Access Compliance Report Public Rights-of-Way (Curb Ramps)

Main Street: ETON_PL Cross Street: MEDFORD_RD Location: NE

ADA ID: RPAT211006150042 Ramp Type: Type 1 - Perpendicular Diagonal Initial Pass/Fail: Fail Overall Compliance: No Severity Score: 16

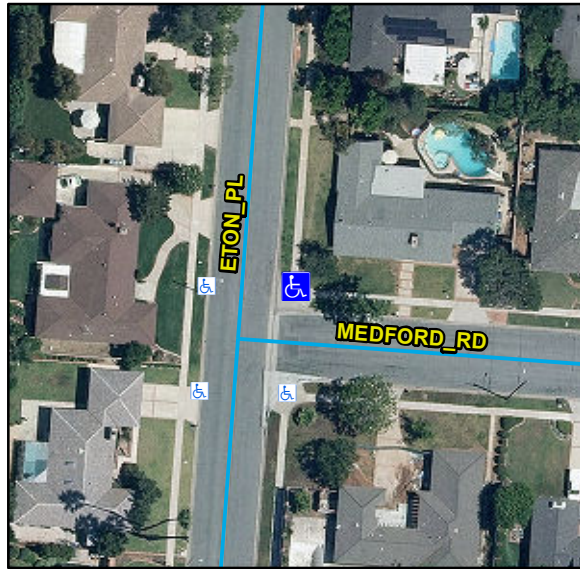
Compliance	Description	Data	Compliance	Description	Data
N/A	Ramp Length (in)	113	N/A	Flare Type LT	
Yes	Ramp Width (in)	52			N/A
No	Ramp Run Slope (%)	8.6	N/A	Flare Slope LT (%)	N/A
Yes	Ramp Cross Slope (%)	0.5	N/A	Flare Traversable LT	N/A
N/A	Landing Present	N/A	N/A	Flare Type RT	
N/A	Landing Length (in)	N/A			N/A
N/A	Landing Width (in)	N/A	N/A	Flare Slope RT (%)	N/A
N/A	Landing Run Slope (%)	N/A	N/A	Flare Traversable RT	N/A
N/A	Landing Cross Slope (%)	N/A	N/A	DWS Provided	N/A
N/A	Landing Movement Obstructed?	N/A	N/A	DWS Contrast	N/A
	Landing Movement Type	N/A	N/A	DWS Length (in)	N/A
N/A	Landing Shared	N/A	N/A	DWS Full Width	N/A
N/A	Clear Space	Yes	N/A	DWS Offset Left (in)	N/A
N/A	Clear Space To Crosswalk (in)	N/A	N/A	DWS Offset Right (in)	N/A
N/A	Marked Crosswalk 1	No	N/A	Marked Crosswalk 2	No
	Crossing 1 Direction	W		Crossing 2 Direction	S
	Marked Crosswalk 1 Width (in)	N/A		Marked Crosswalk 2 Width (in)	N/A

N/A	Ramp Inside Crosswalk 1	N/A	Yes	Ramp Inside Crosswalk 2	N/A
	Crossing 1 Slope (%)	3.5		Crossing 2 Slope (%)	0.8
	Crossing 1 Cross Slope (%)	1.1		Crossing 2 Cross Slope (%)	3.5
N/A	Gutter Ponding	N/A	No	Curb Slope	9.2
Yes	Gutter Lip Height (in)	0		Road Run Slope (%)	0.5
N/A	Gutter Run Slope (%)	N/A		Road Cross Slope (%)	2
N/A	Gutter Cross Slope (%)	N/A			
Yes	Overall Surface Condition: Acceptable		Yes	Perp Joint Present	Yes
	Cross Gutter Present?	Yes		Spandrel Present?	Yes
	Replace Cross Gutter?	No		Replace Spandrel?	No

Remove & Replace Curb Ramp With Two New Directional Ramps or Equivalent.

R304.2.2, STD 1115
